Access Compliance Report

Public Rights-of-Way

(Curb Ramps)

Intersection ID: 48475	Main Street: SHALLOW_OAK_CT	Cross Street: AUTUMN_OAK_DR	Location: W
ADA ID: FD7B04023E9C	Ramp Type: PerpDiag	Initial Pass/Fail: Fail	Overall Compliance: No
Severity Score: 73.75			
Codes/Mitigation Info/Possible Solution		Field Measurements/Component Compliance

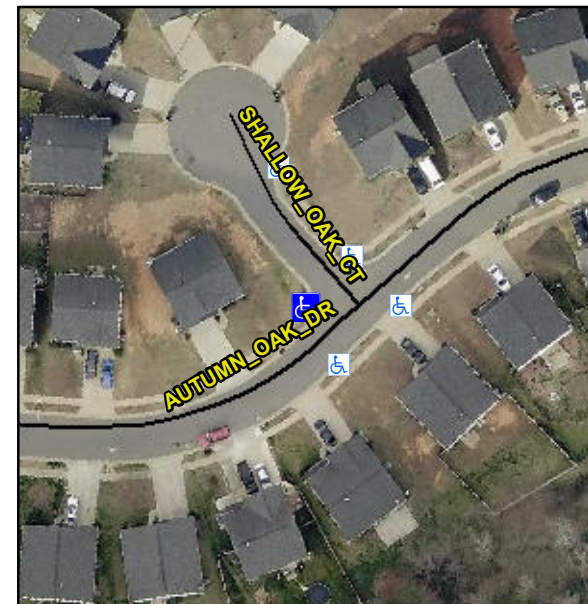
Not Found, R304.5.1, R304.2.2, R304.5.3, R302.7

Compliance	Description	Data	Compliance	Description	Data
N/A	Ramp Length (in)	49.5	No	Ramp Slope (%)	17.0
No	Ramp Width (in)	46.5	No	Ramp XSlope (%)	7.6
N/A	Flare Type LT	N/A	N/A	Flare Type RT	N/A
N/A	Flare Slope LT (%)	N/A	N/A	Flare Slope RT (%)	N/A
N/A	Flare Traversable LT?	N/A	N/A	Flare Traversable RT?	N/A
N/A	Landing Length (in)	N/A	N/A	DWS Provided?	N/A
N/A	Landing Width (in)	N/A	N/A	DWS Contrast?	N/A
N/A	Landing Slope (%)	N/A	N/A	DWS Length (in)	N/A
N/A	Landing X Slope (%)	N/A	N/A	DWS Full Width?	N/A
N/A	Landing Curb? (Y/N)	N/A	N/A	DWS Offset (in)	N/A
N/A	Shared Landing?	N/A			
N/A	Gutter Ponding?	N/A	N/A	Gutter Slope (%)	N/A
N/A	Gutter Lip Ht (in)	N/A	N/A	Gutter X Slope (%)	N/A
N/A	Painted X Walk1?	No	N/A	Painted X Walk2?	No
	X Walk 1 Direction	To SE		X Walk 2 Direction	To NE
N/A	X Walk 1 Width (in)	N/A	N/A	X Walk 2 Width (in)	N/A
	X Walk 1 Slope (%)	1.1		X Walk 2 Slope (%)	5.2
	X Walk 1 X Slope (%)	4.2		X Walk 2 X Slope (%)	4.6

N/A	Ramp inside XWalk1?	N/A	N/A	Ramp inside XWalk2?	N/A
	Road Slope (%)	6.0	N/A	Clear Space?	N/A
	Road X Slope (%)	1.7	N/A	Clear Space to XWalk (in)	N/A
N/A	Any Obstructions?	N/A	N/A	Storm Grate/Utility Hazard?	N/A
	Obstruction Type			Storm Grate/Utility Type	
		N/A			N/A
		No		Surface Condition? (G/P)	Poor

Remove & Replace Curb Ramp With Two New Directional Ramps or Equivalent.
